10 Battery Point Lane

Variance Request

STAFF REPORT: ZONING BOARD OF APPEALS (ZBOA)

Background: The applicant submitted an application on March 1st to request a variance from Beaufort Code Section 2.4.1.C.3 to allow a proposed detached garage to encroach 3 ft into the required 5 ft side setback for accessory structures.

A101
Proposed Floor Plan

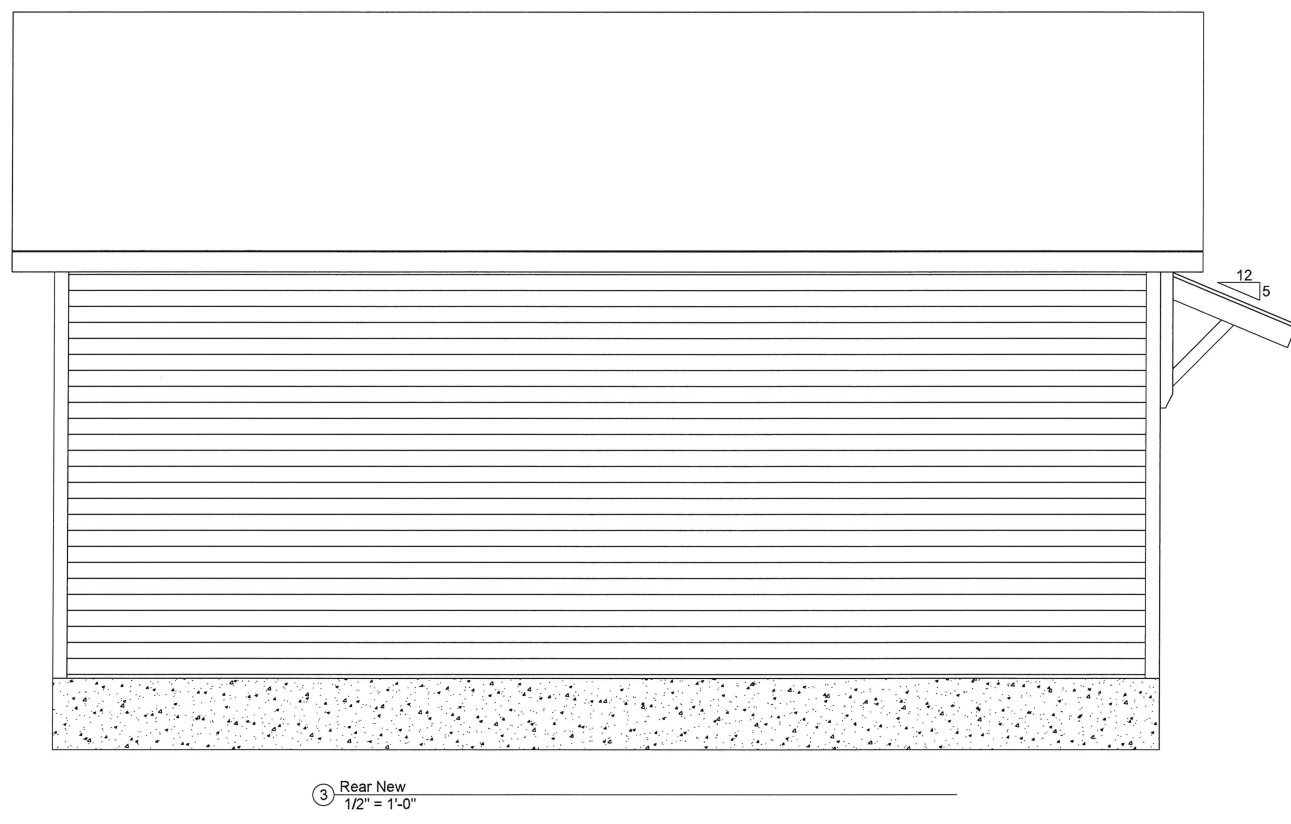
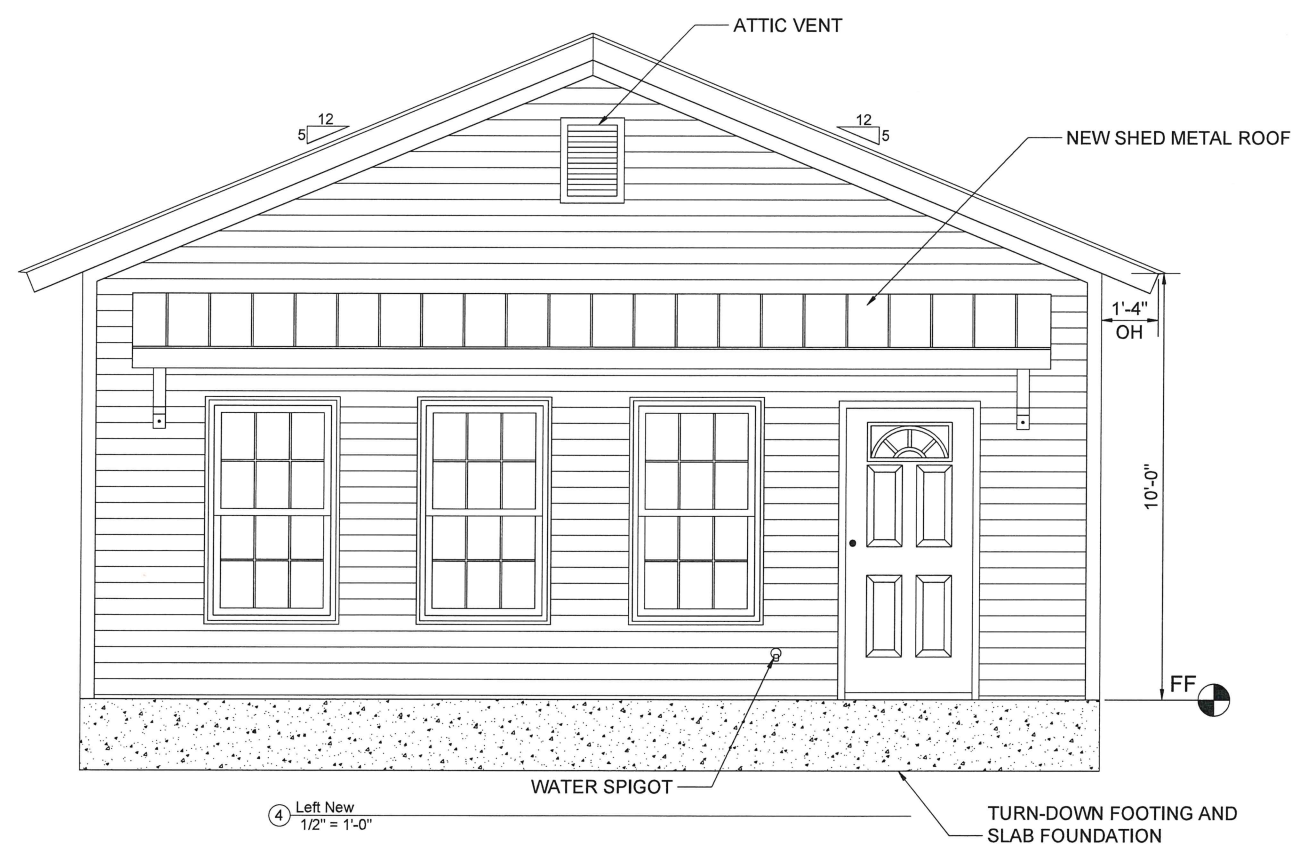
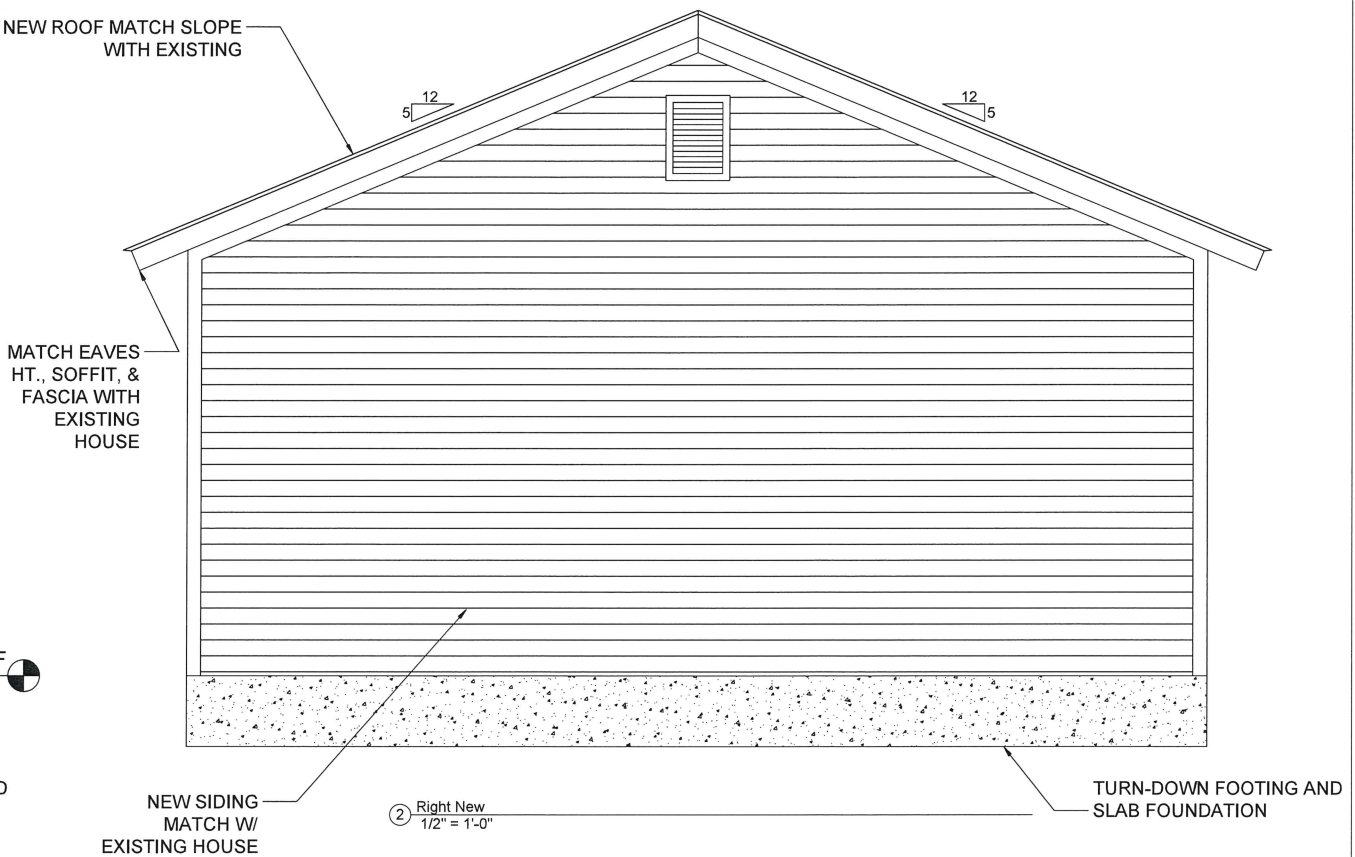
BPARC requested that Neighbor side of Conceptual Plans be updated with 2 Twin Windows.
